August 30, 2013

PILGRIM WATCH'S 2.206 PETITION TO MODIFY, SUSPEND, OR TAKE ANY OTHER ACTION TO THE OPERATING LICENSE OF PILGRIM STATION UNTIL THE NRC CAN ASSURE EMERGENCY PREPAREDNESS PLANS ARE IN PLACE TO PROVIDE REASONABLE ASSURANCE PUBLIC HEALTH & SAFETY ARE PROTECTED IN THE EVENT OF A RADIOLOGICAL EMERGENCY

The primary basis for this petition is two recent documents prepared by KLD for Entergy: The *KLD Pilgrim Evacuation Estimate December 12, 2012 Final Report KLD-TR-510*² (Hereinafter, "ETE") and the attached *KLD MEMO to John Giarrusso (MEMA) from Chris Chaffee (KLD) Regarding the Cape Cod Telephone Survey Results*, July 25, 2013, attached (Hereinafter, "Cape Survey"); and the attached August 16, 2013 Letter from Senator Markey and Senator Warren regarding Pilgrim's ETE and Cape Telephone Survey to Leo Denault (Entergy) and forwarded to Chairman MacFarlane's Office.

Figure 2. Evacuation Due to an Incident at PNPS

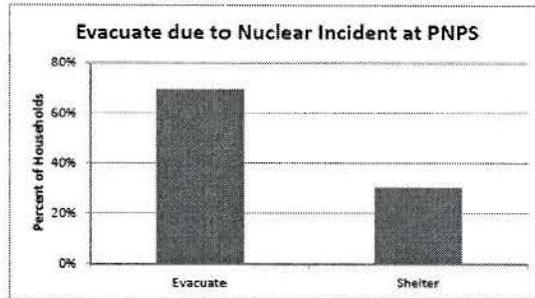
The Cape Cod Telephone Survey could not more clearly show that if potentially affected respondents were asked "would you evacuate" "if they were an incident at the Pilgrim Nuclear Power Station," 70% (not the 20% assumed by the NRC or the 19% of the ETE) would do so.

It is hardly surprising that many more respondents said they would evacuate when they were told that there had been a nuclear incident at Pilgrim than if neither Pilgrim, nor nuclear, nor radiological were even mentioned. The Cape Telephone Survey clearly demonstrates that the ETE Telephone Survey, that intentionally did not tell respondents upfront that the question refers to what they would do if there was an accident at the nuclear power plant, is not credible and cannot provide any basis for Pilgrim's evacuation time estimates.

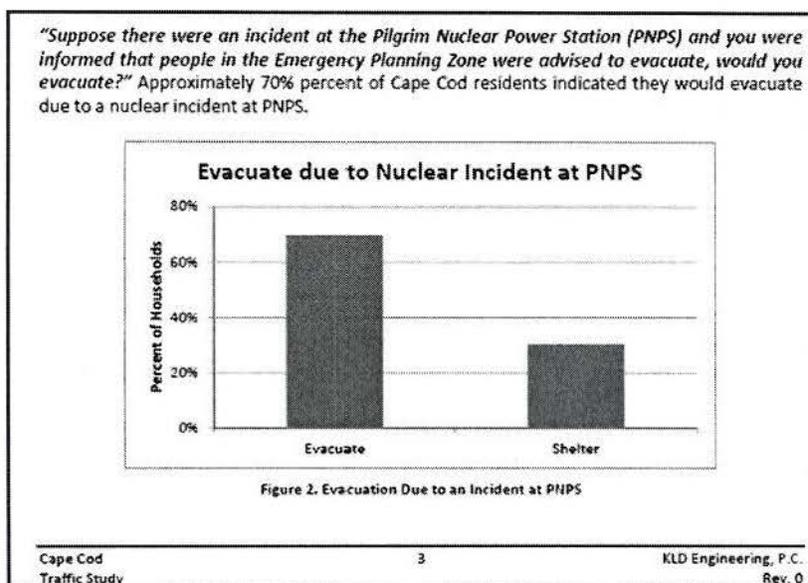
The Cape Survey, in stark contrast, told respondents the purpose of the survey and because it did the shadow evacuation estimates were very large. The Cape Survey specifically asked respondents, “If you were told that Cape Cod is not in the Emergency Planning Zone for the Pilgrim Nuclear Power Station, would you still evacuate? (Cape Survey Question 3B), “Approximately 50 percent of the Cape Cod residents indicated that they would evacuate due to a nuclear incident at PNPS, even knowing they were not in the Emergency Planning Zone (EPZ (Cape Survey, 4)

The results of the Cape Survey show, at a 95% confidence level, that the ETE's assumption that no more than 20% will evacuate is not just wrong; it is ludicrous. It cannot properly be used to determine Pilgrim's evacuation time estimates.
